BIDDERS BULLETIN

PROJECT: New Auto Service & Car Wash Building
Modern Muffler Tire Pro
1402 South Jeffers
North Platte Nebraska

BB-1

DATE ISSUED: April 23, 2012

WashSoft Traffic-Management WashServer Area Hardware Layout

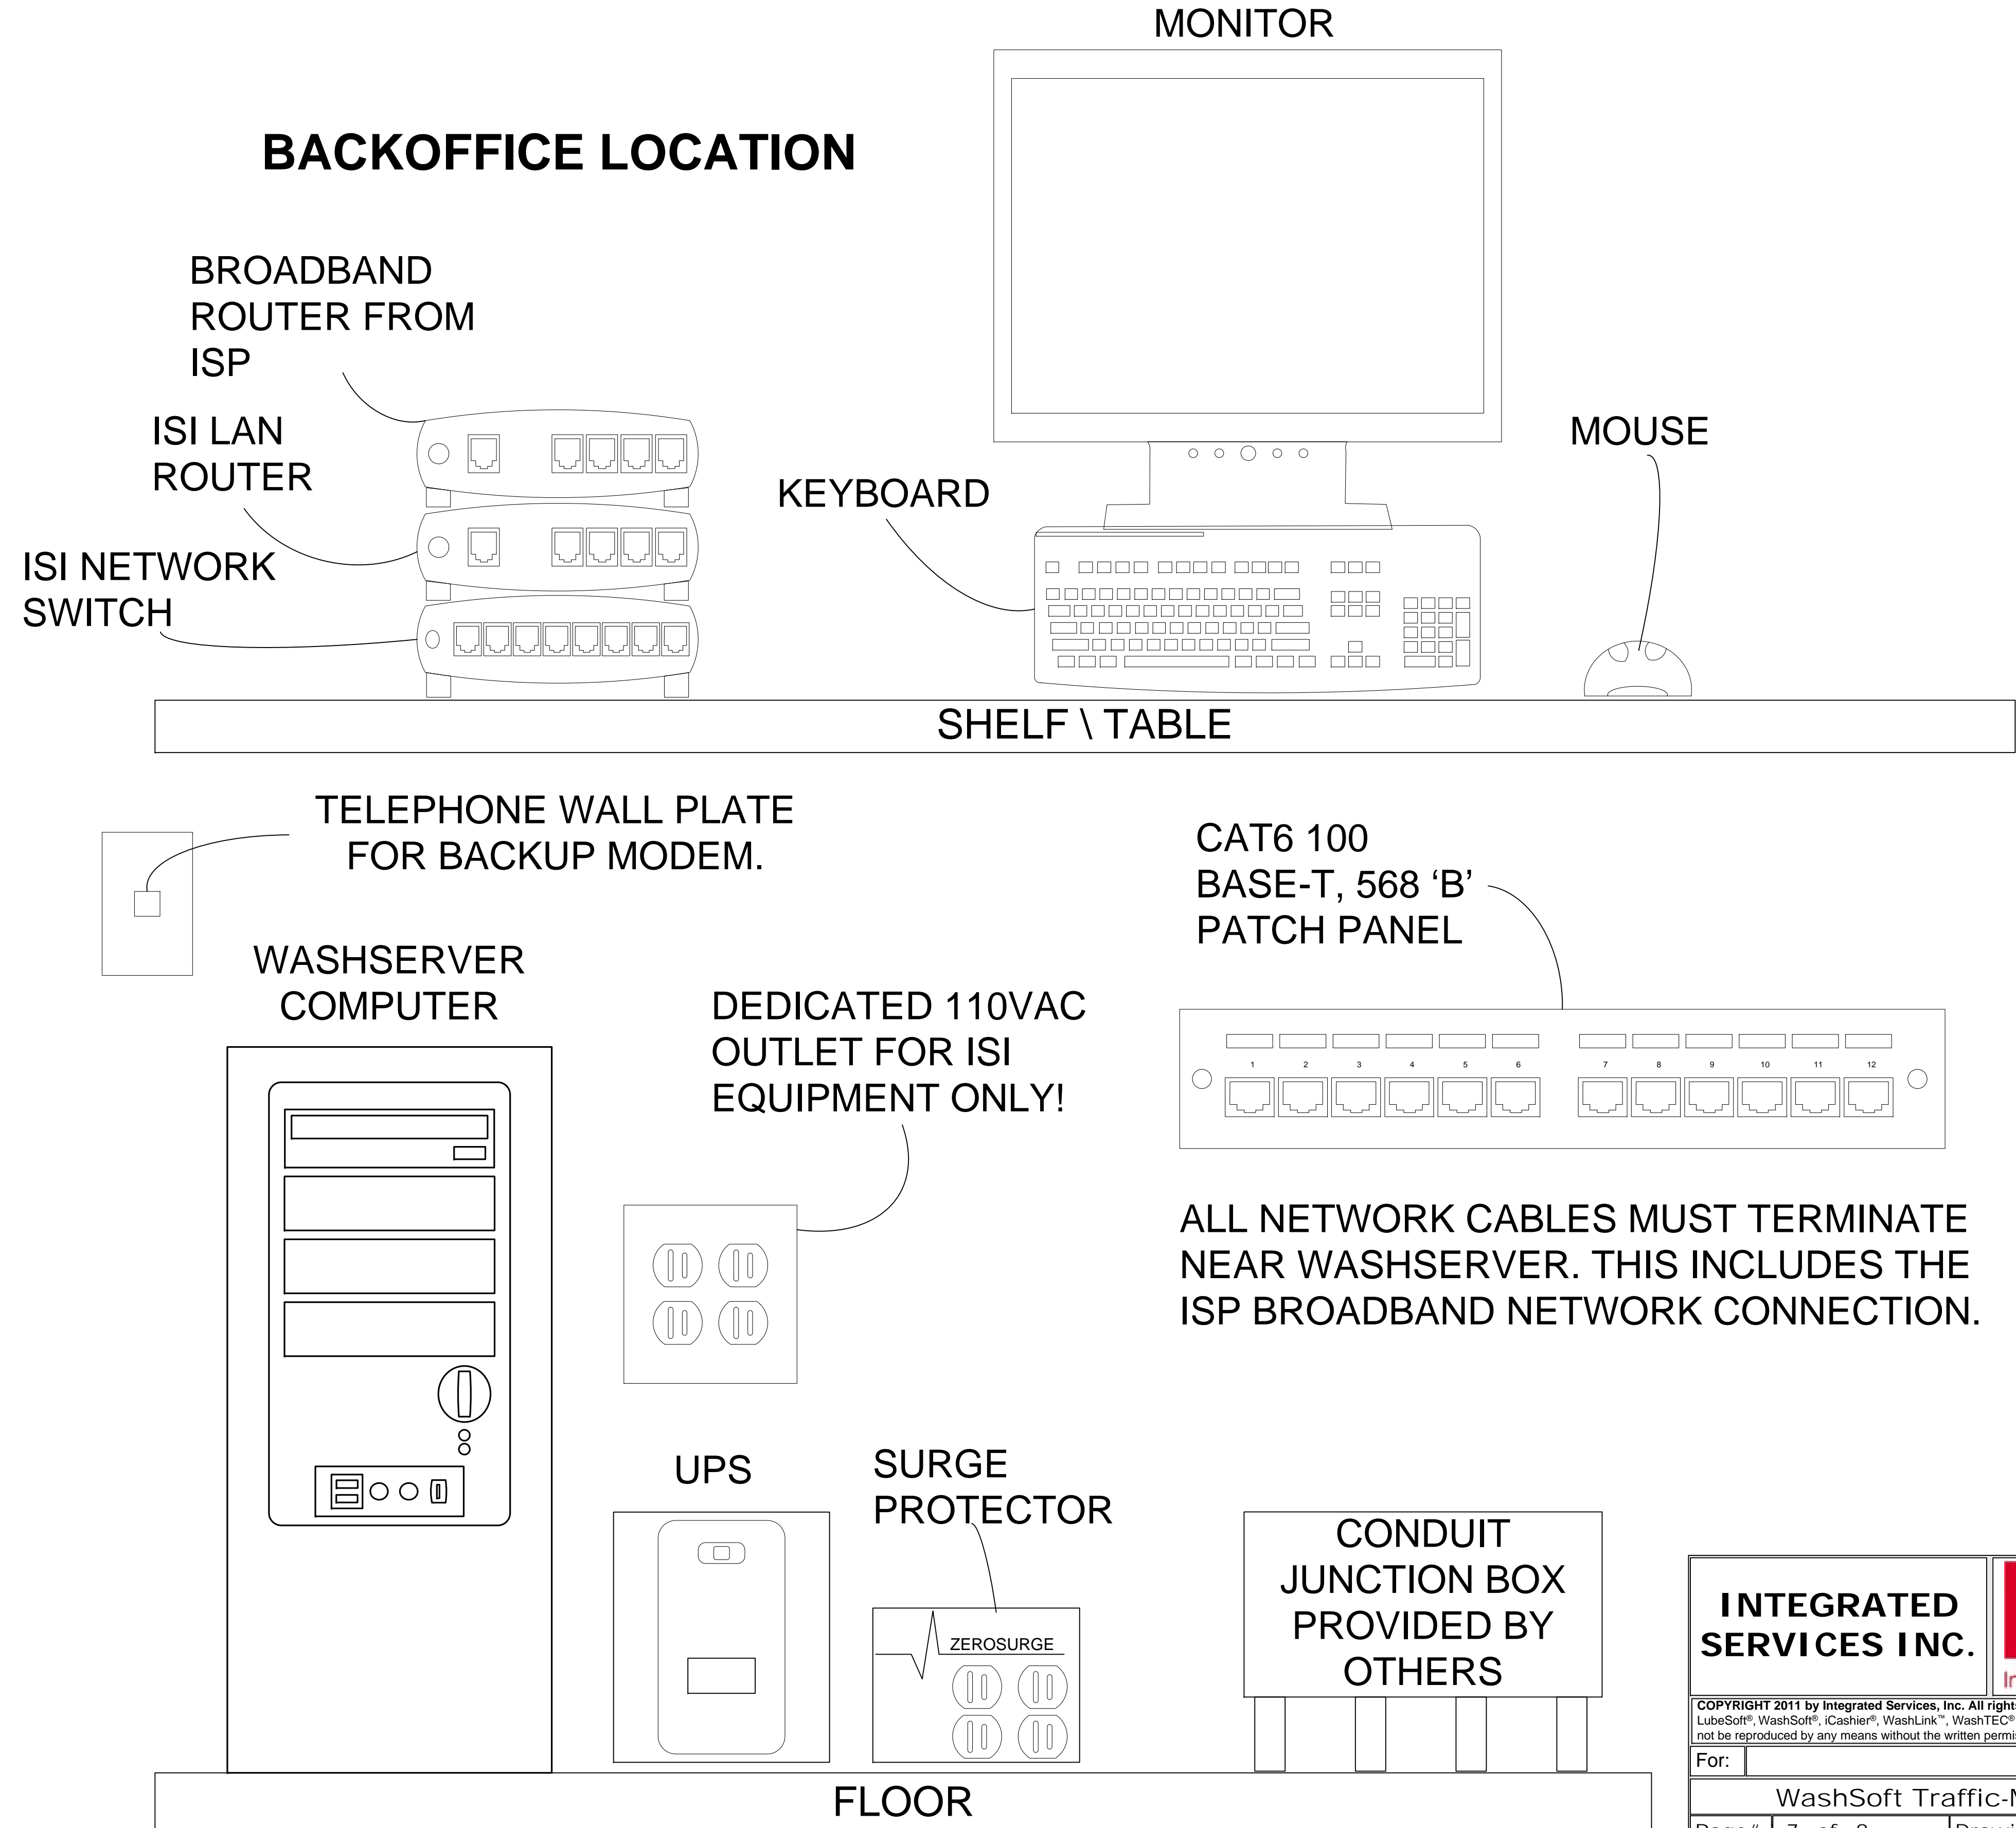
Item #13: E201 – Traffic Management System: Provide conduits and control wiring for traffic management system furnished by Integrated Services Inc. (ISI) as called out on Traffic Management drawings included in this addendum. Coordinate exact requirements with owner and supplier.
